The Corporation of the District of Saanich

Report

Subject: 961 McKenzie Avenue, and 3986 and 3990 Saanich Road - Development Permit and Rezoning Application

File: DPR01057, REZ00751

Figure 2. Landscape Plan. Adapted. From plans by Gauthier & Associates Landscape Architects Inc.

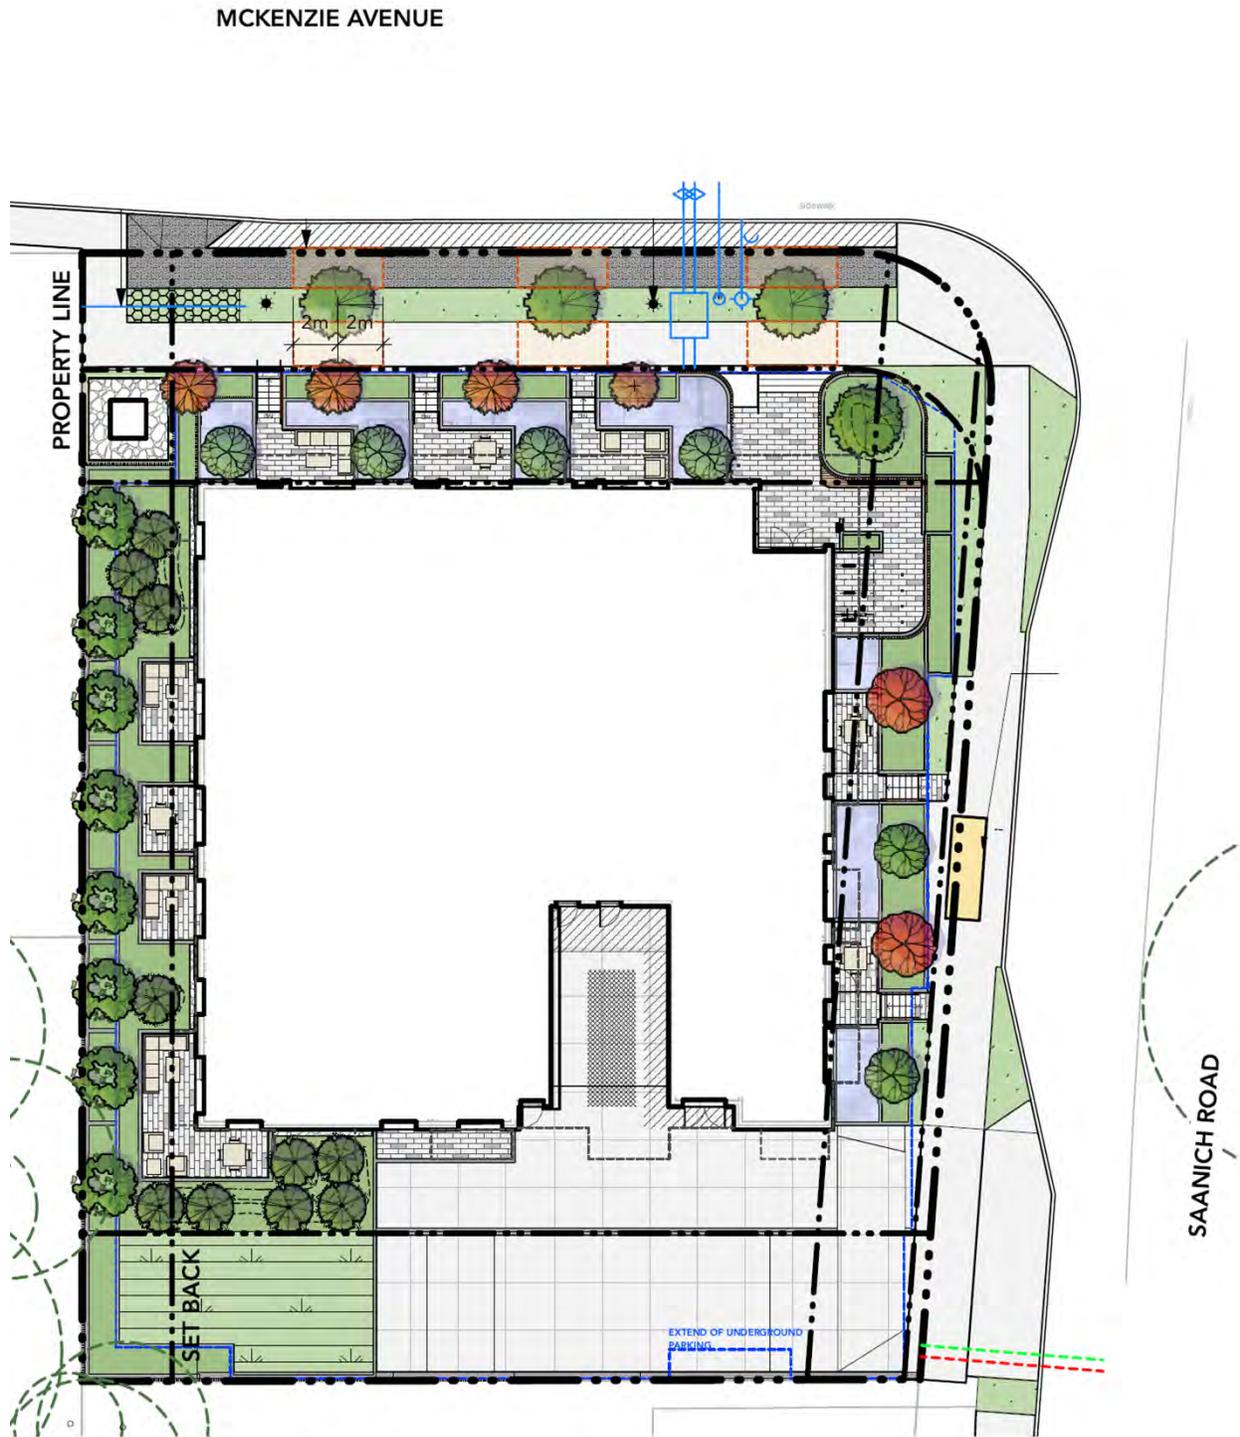
The site has notable tree canopy, as identified in the 2000 LAP, but tree retention has proven difficult. The building's siting will necessitate the removal of all trees on site. For the removal of 22 bylaw-protected trees, 31 replacement trees are being planted, and cash-in-lieu will be required for 13 additional trees. Retaining more trees is not feasible on a site of this size while maintaining the same proposed density: shrinking the building footprint would come with the trade-off of significantly increased height. On-site and boulevard plantings have been included,

where possible, to help maintain the urban forest canopy. Three Garry oaks will be planted in the boulevard along McKenzie Avenue.

Vehicle access to underground parking, loading, and other "back of house" uses are located on the site's south side (DPAG 6.1.4 a.). The parkade ramp is next to the property line, whereas there would ideally be landscaping buffering the ramp from the adjacent property (DPAG 3.1.4 w.). The applicant responded to staff feedback to increase green and open space by including landscaping over the waste and recycling room in the southwest corner of the site (DPAG 3.1.5 a.).
